Metropolitan Planning Commission

Staff Reports

June 12, 2008

**PREVIOUSLY DEFERRED ITEM
COMMUNITY PLAN
AMENDMENT**

2007CP-021U-13 Land Use Policies Before Amendment

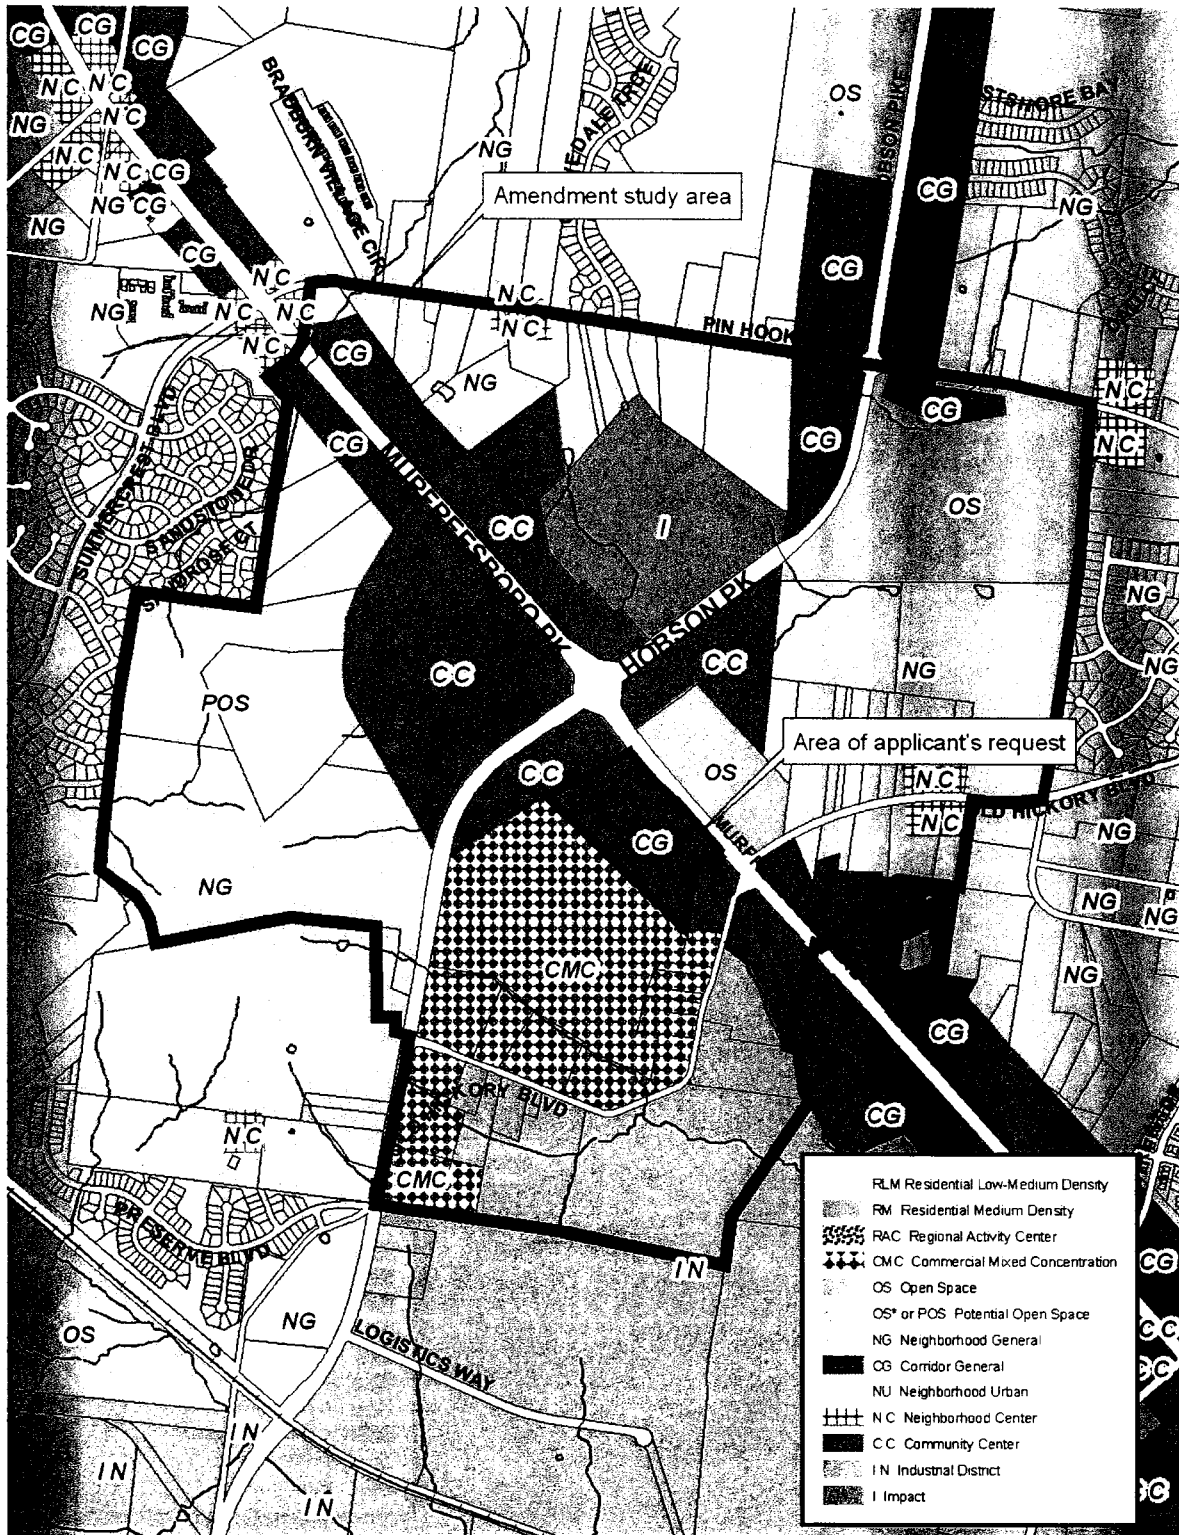
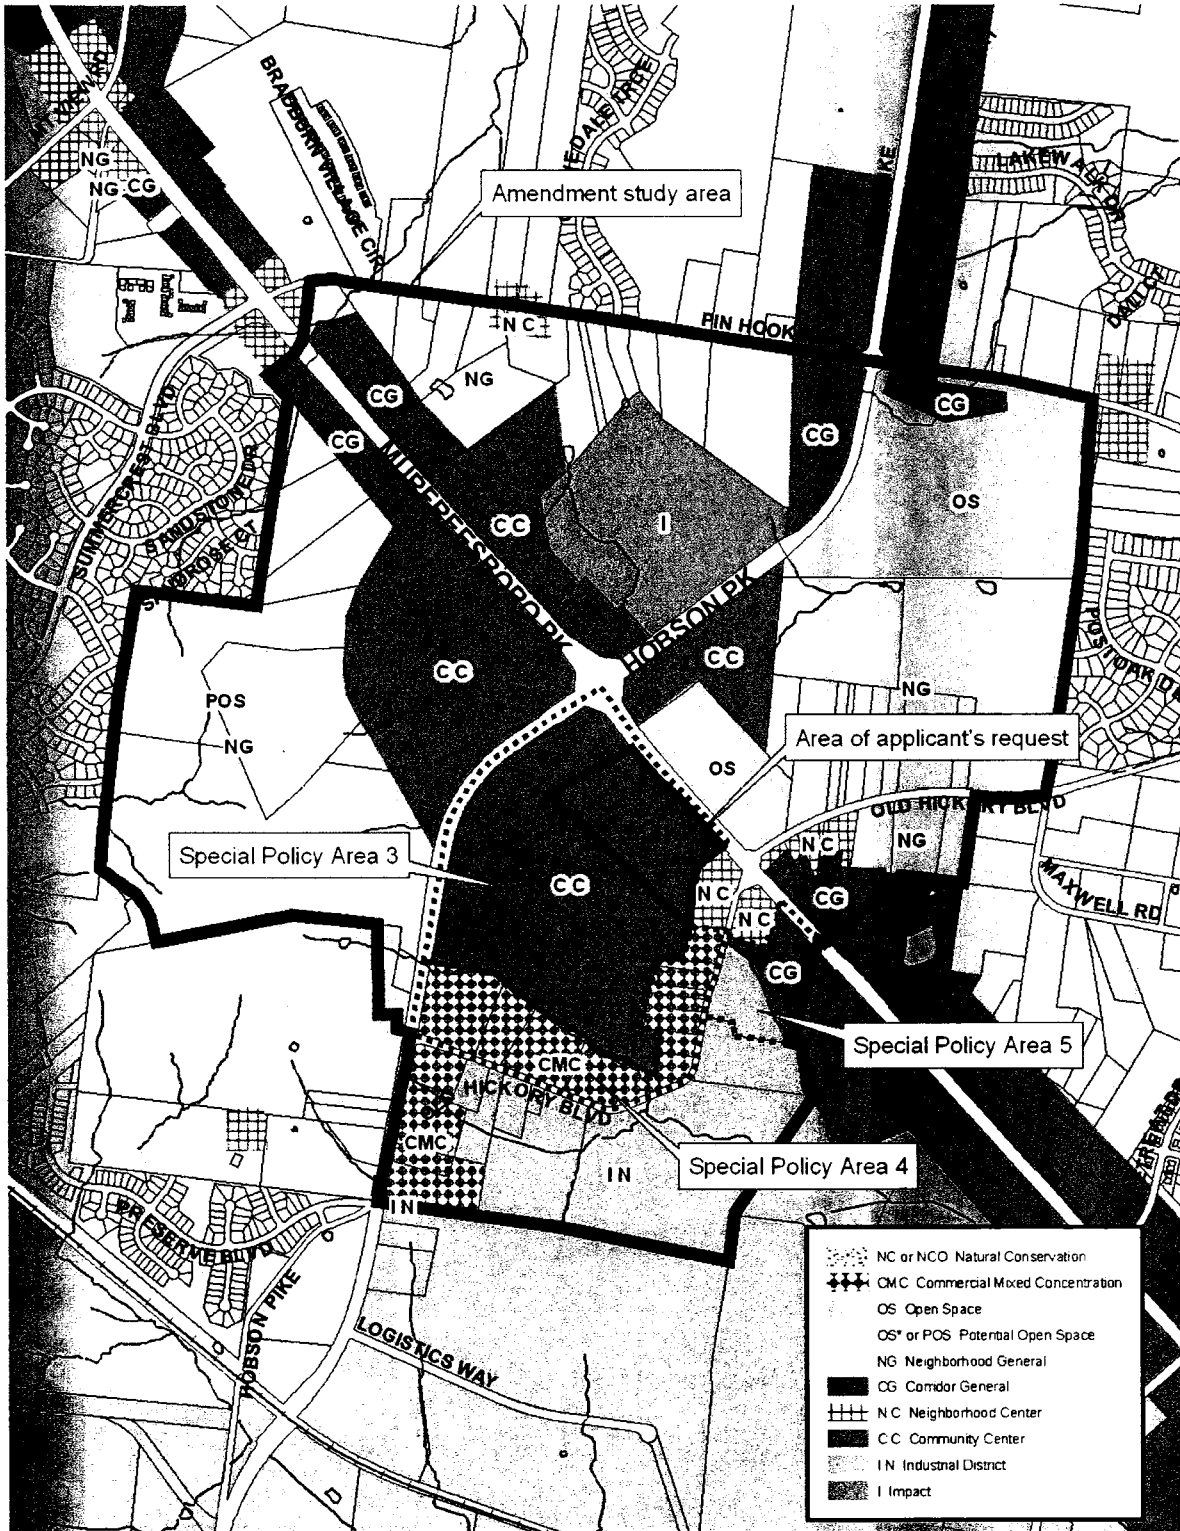
A request to amend the *Antioch-Priest Lake Community Plan: 2003 Update* to replace Corridor General land use policy with Community Center land use policy for a portion of Map 164, Parcel 41 located along the south margin of Murfreesboro Pike at Hobson Pike.

Planning staff has reviewed the policies within the overall amendment study area that was established for this case and is recommending a few other associated policy changes. One is to move the Neighborhood Center node that is located approximately 1,200 feet east of Murfreesboro Pike from its current planned location to the intersection of Old Hickory Boulevard and Murfreesboro Pike, where there is already some commercial zoning in place. There is no commercial zoning at the current N C location and it is more likely that the policy will be implemented at the proposed location. In addition, staff recommends that Special Policies be put in place in the area as specified below.

Staff recommends approval of Community Center policy, Neighborhood Center policy, and accompanying Special Policies as outlined above.

Special Policy Area 5: Transitional Industrial Parcel on Murfreesboro Pike East of Old Hickory Boulevard

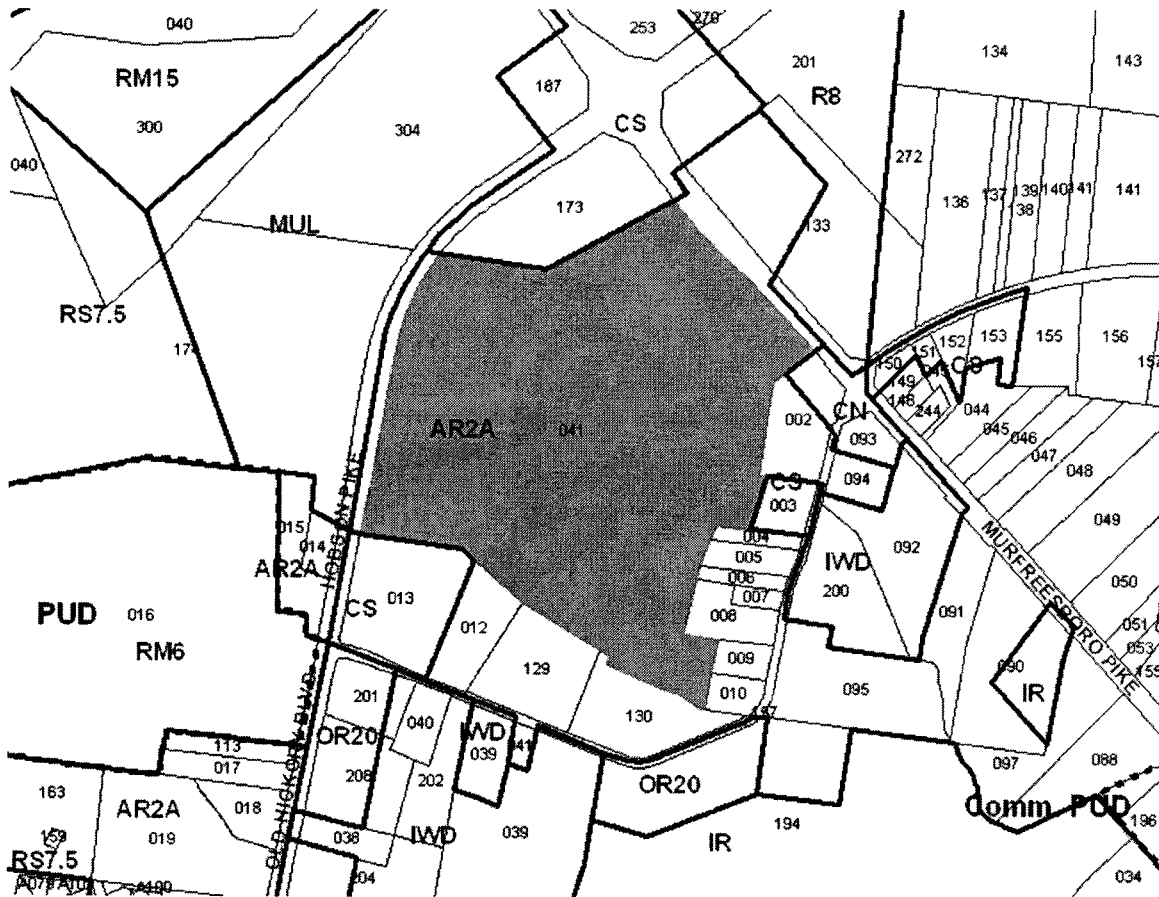
The following guidance should be followed for the development of this site, the current use of which does not conform to the land use policy, in order to bring it into future conformance with the community plan:

This parcel is zoned IWD and contains a light industrial use. The portion of the parcel that is south of the stream that bisects the property is in Industrial policy while the northern portion, which adjoins Murfreesboro Pike, is in Corridor General policy. To aid in implementing these policies, the property should not be rezoned to IR or IG, but rather should be rezoned to either a base district that would create a transition towards the intended policy arrangement combined with either a Planned Unit or Urban Design Overlay, or should be rezoned to a Specific Plan District that achieves the same intent. Applicants are encouraged to work with the Planning Department to establish the most appropriate combination of uses and urban design on the site, with the understanding that the site's Murfreesboro Pike frontage is most appropriate for shallow setbacks with very limited parking in front of the building and a solid street wall.

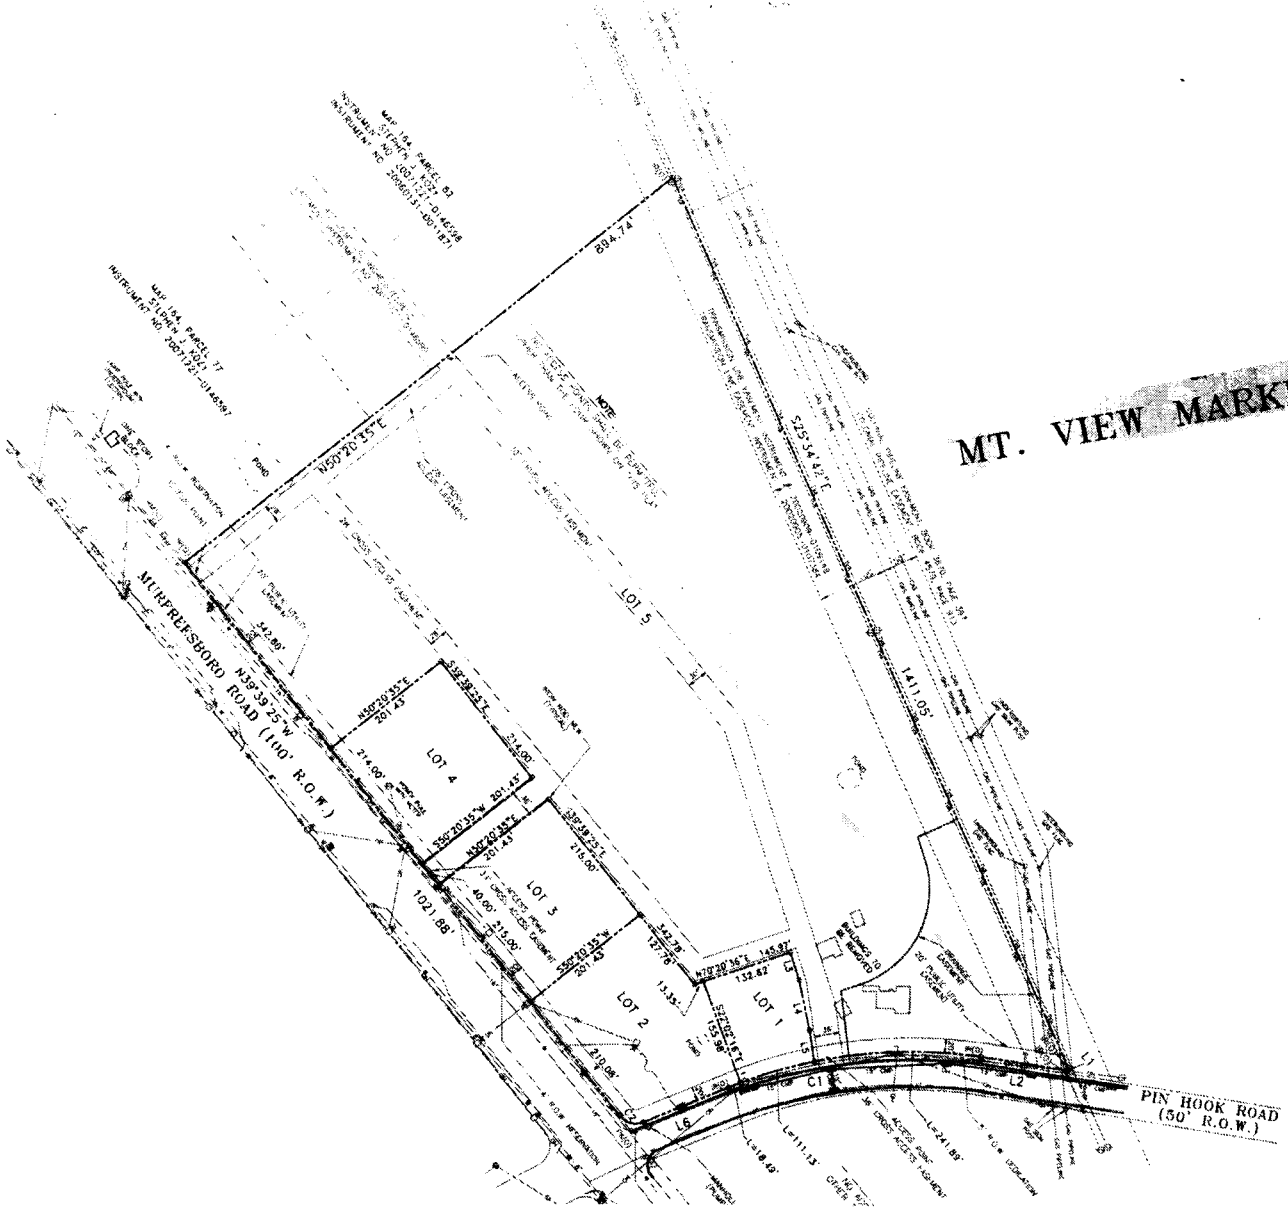
The final plat proposes to modify the property lines of five existing parcels to create five commercial lots. This includes one large lot of 15.96 acres and four out parcels ranging in size from 0.63 acres to 1.18 acres. The out parcels front Pin Hook Road and Murfreesboro Pike with the bulk of the large lot to the rear.

- Cross access easement between Lot 5 and Parcels 82 and 77 shall abut the existing property line.
- Additional ROW may be required along Murfreesboro Road and Pinhook Road to accommodate off-site road improvements and signal structures.
- Prior to the recording of the final plat, construction plans are to be approved by the Department of Public Works. Off-site improvements are to be bonded with the recording of the final plat.

1. The northwest access onto Murfreesboro Pike shall be moved to the property line.
2. Prior to the recording of the final plat, construction plans are to be approved by the Department of Public Works. Off-site improvements are to be bonded with the recording of the final plat.

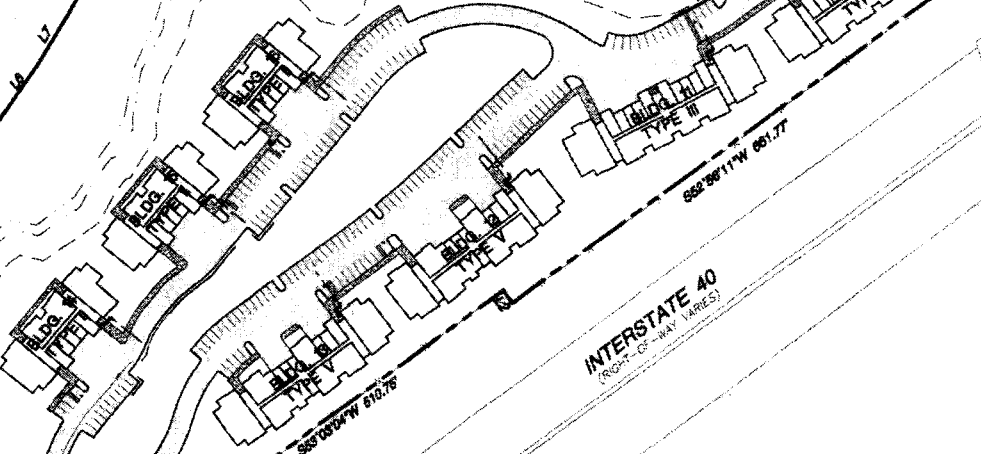
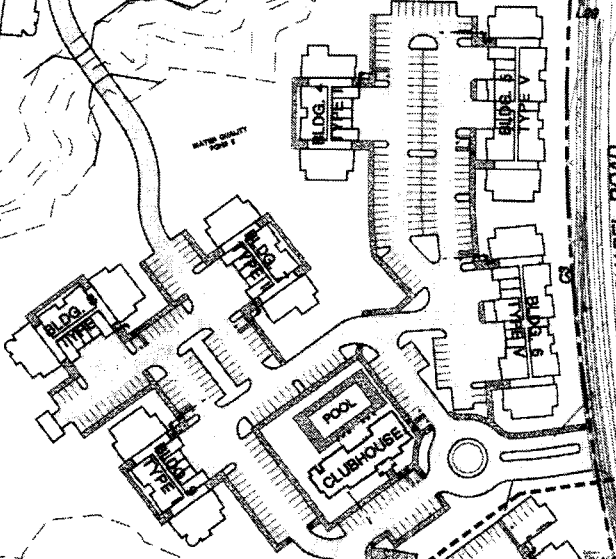
3. Provide an initial erosion control measure sheet. This is to show the initial erosion control measures on existing contours. Show the sediment basins (and diversions) on this sheet. Be sure that silt fence is placed on level contours.

5. For the erosion control measures (during construction), show silt fences on level contours, add outlet protection to HW's 20, 31, 40, and 3. Reference Metro BMP's for the erosion control measures.

6. If construction is anticipated to be over 12 months, include a construction schedule.
7. Provide all civil details (matting, etc.).
8. For the storm structures, provide a drainage map for the area draining to JB 51 and inlet 38. Drainage map indicated a pipe connecting the offsite pipe (near inlet 38) to 38. This was not observed in the construction plans. This offsite drainage should be picked up and handled (routed) through site.

9. For the storm structures, spread appears high for inlets 36, 37, and 38.
10. For the storm structures, no "R" sheets were provided.
11. In order to eliminate detention, provide information for the 10% rule. If detention is required, provide pre-condition hydrographs (and pre CN / Tc information).

12. The emergency spillway was not shown on the plans for ponds 1 or 2. Also, show top of pond elevations (to show that adequate freeboard exists).

13. For the rain garden, provide a cross section (showing materials to be used and elevations).
14. For micropool extended detention 1, adequate acreage does not exist. Revise or provide water budget calculations.
15. The permanent pool elevation (pond 2) was misidentified on the plans (C10).

1. Comply with all conditions of the original council bill (BL2004-325).
2. Comply with all Stormwater conditions.
3. Comply with all Public Works conditions.
4. Add 8' pedestrian paths that connect the stairways in Buildings 5 and 6 to Dodson Chapel Road.
5. Extend pedestrian trail easement from the trail west of the proposed pump station to the future phase to the west.
6. Add three sections of pedestrian paths to complete the pedestrian network.
7. Submit plans for building permit review that comply with the UDO final site plan approved by the Planning Commission and include architectural elevations for the apartment buildings and club house.
